Wellington Regional Council
Harbourmaster's Direction 4B/2024
Changes to entrance channel and approaches

To: Pilots and PEC Masters of vessels over 500GRT using Wellington Harbour entrance.

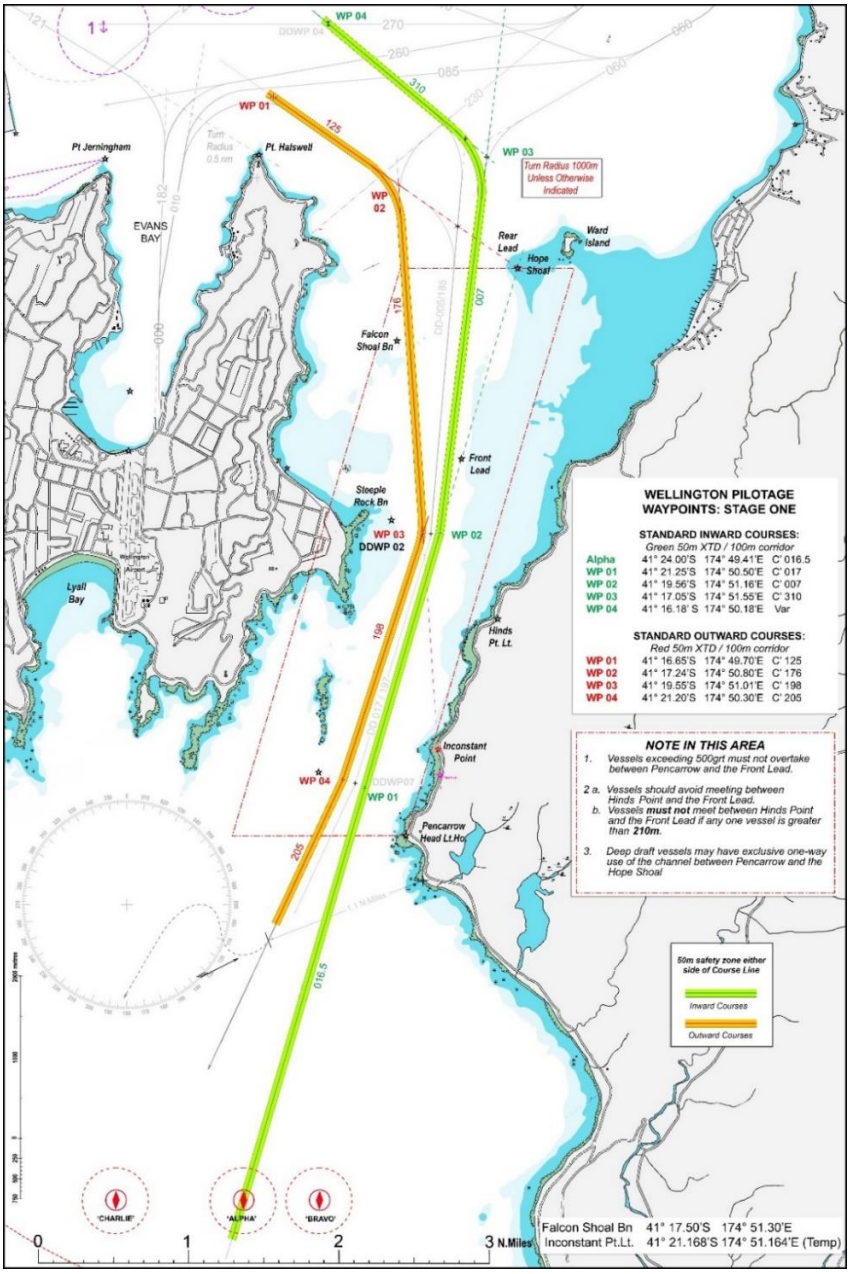
From 12 June 2026 the inward and outward tracks will change in line with the details below and the introduction of a precautionary zone. The precautionary zone is of similar length to the narrow channel defined in Schedule 6 of the Navigation Safety Bylaws, however it is wider to include the new Falcon Shoal beacon. The Precautionary zone is shown on the chartlet below.

- From 12 June 2026 vessels may use the Inward and Outward tracks as indicated in figure one below. These replace the relevant waypoints in Schedule 5 of the Bylaws.

- By Monday 29 June all applicable vessels are expected to be using the new standard tracks as indicated in Figure one below.
- Vessels of 500GRT should avoid meeting an opposing vessel between Hinds Point and the Front Leading Light.

- No vessel departing Wellington Harbour is to proceed west of the new Falcon Shoal beacon, position: 41° 18.28' S 174° 50.79' E.
- From 24 May 2026 the two Falcon Shoal Piles will display lights different to the chart; the existing pile will have a yellow light and the new Pile a red light, both with the same character.

- Where one of the vessels above is over 210metres overall, they shall not meet between Hinds Point and the Front Leading light.
- From time to time, with prior notice, a deep draft channel may be declared that will grant a deep draft vessel exclusive one-way use of a deep draft channel between Pencarrow light house and Rear Leading Light. This will restrict use of the standard tracks in that area. The process is found in Harbourmaster Direction 02/2026.

- From time to time outward bound vessels may be asked to travel outwards passing east of the location of the old Falcon Shoal pile. This will be notified at least a week in advance and will only apply to daylight sailings.
